**3GPP TSG CN Plenary Meeting #21**  
**17<sup>th</sup> – 19<sup>th</sup> September 2003 Frankfurt, GERMANY.**

**NP-030380**

**Source:** TSG CN WG4  
**Title:** Corrections on mobile OoBTC  
**Agenda item:** 7.7  
**Document for:** APPROVAL

⌘ **23.153 CR 062** ⌘ rev **1** ⌘ Current version: **4.8.0** ⌘

**Figure 5.8.3-4/1: Successful Codec Modification including IuFP**

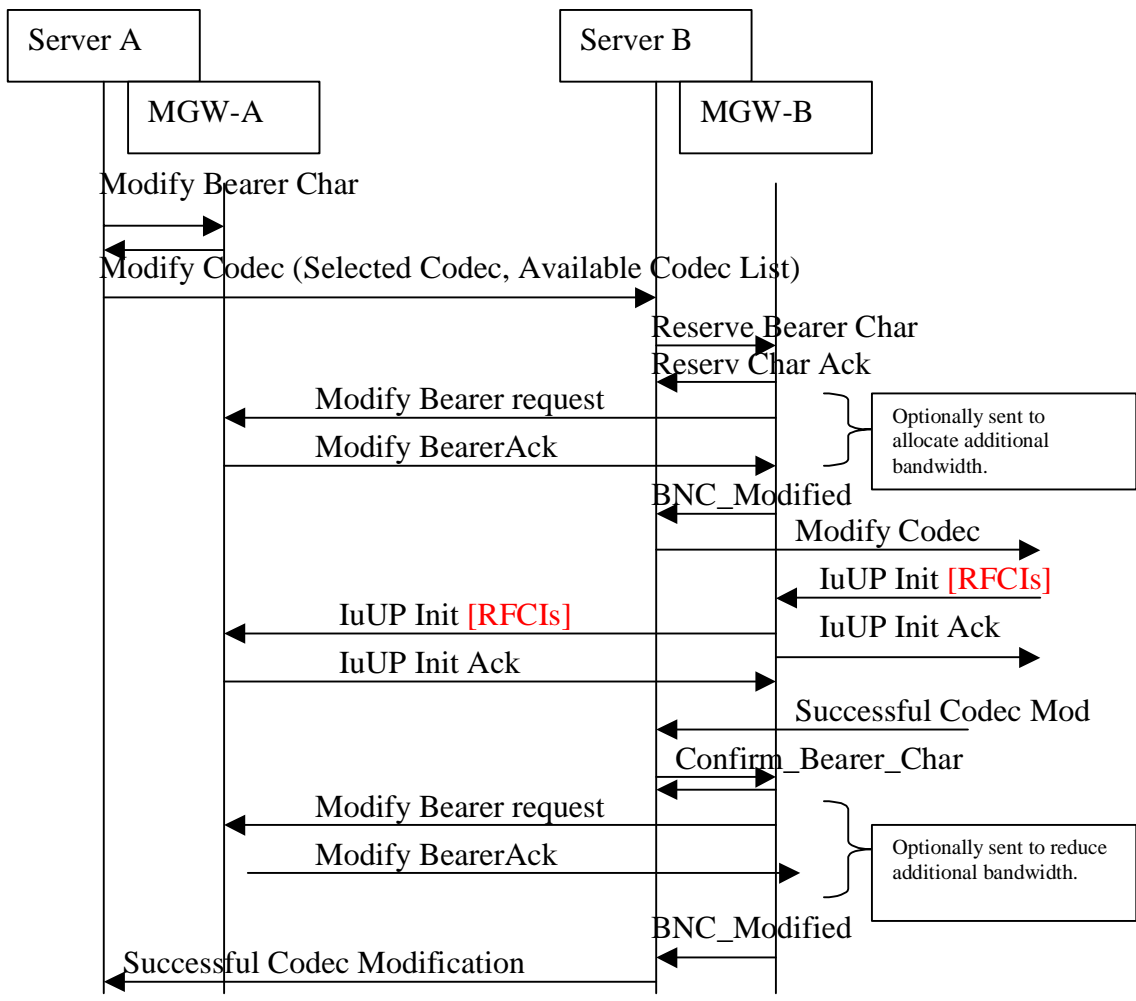
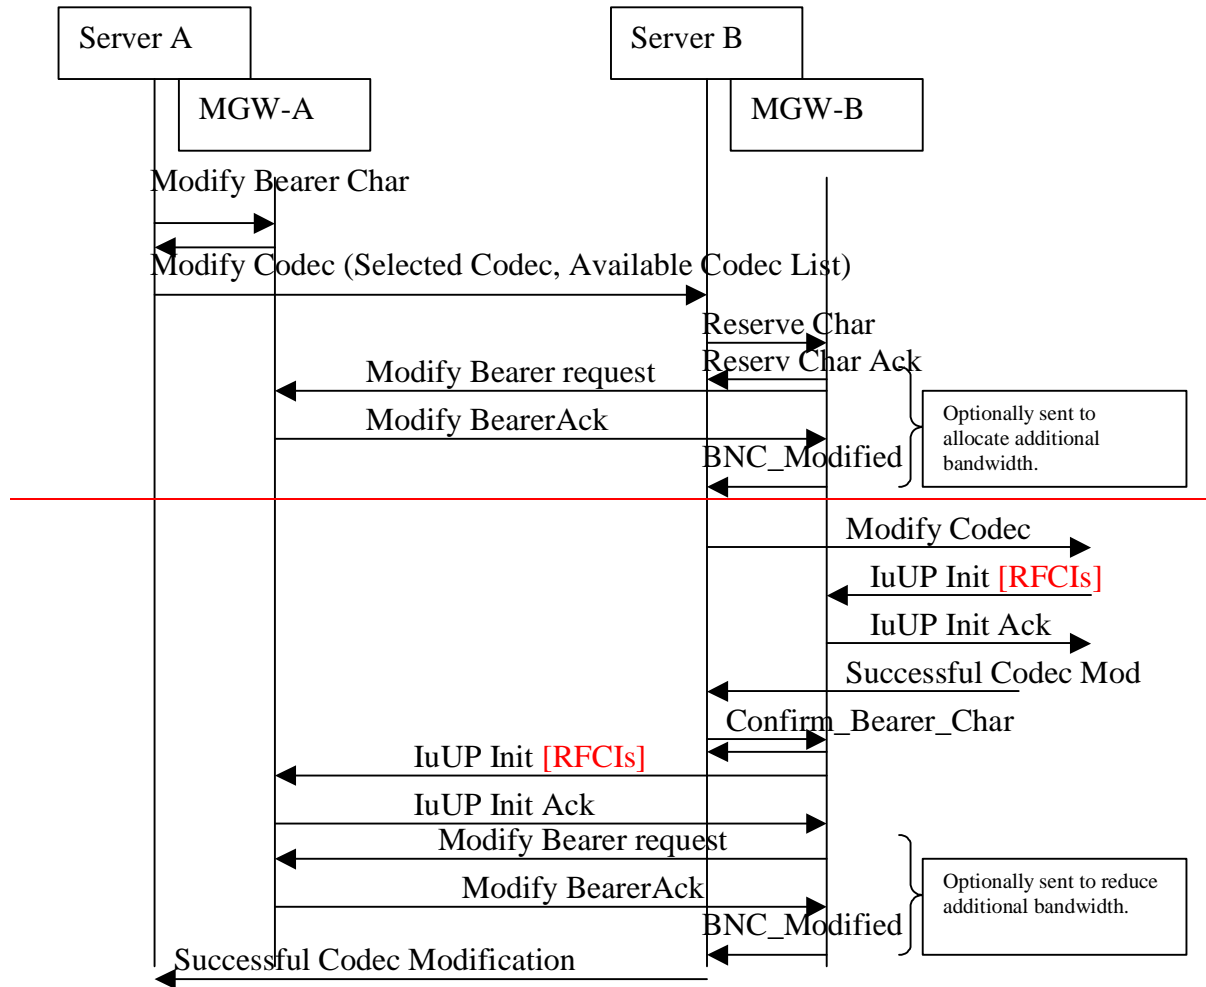
<b>Reason for change:</b>	⌘ 1. Errors in Figures 5.8.4/1, which contradict Figures 5.8.4/2, 5.8.5/1 and 5.8.5/2 and the text in this specification with respect to:  BNC Modified message is required to be sent  UP Initialisation arriving before Confirm Bearer Characteristics should be passed immediately to avoid interruption in speech.  2. Errors in Figures 5.8.4/2:  Optional Bearer Modification to reduce bandwidth omitted (allowed according to BICC and Figure 5.8.1/2)  Rab Assign Modify Response in wrong direction  3. Figure 5.8.5/2 does not fit on one page and will not be printed completely
<b>Summary of change:</b>	⌘ 1. Corrections in Figure 5.8.4/1  BNC Modified message is not optional  Confirm Bearer Characteristics does not trigger UP Initialisation  2. Corrections in Figure 5.8.4/2  Direction of Rab Assign Modify Response turned around  Optional Bearer Modification to reduce bandwidth added
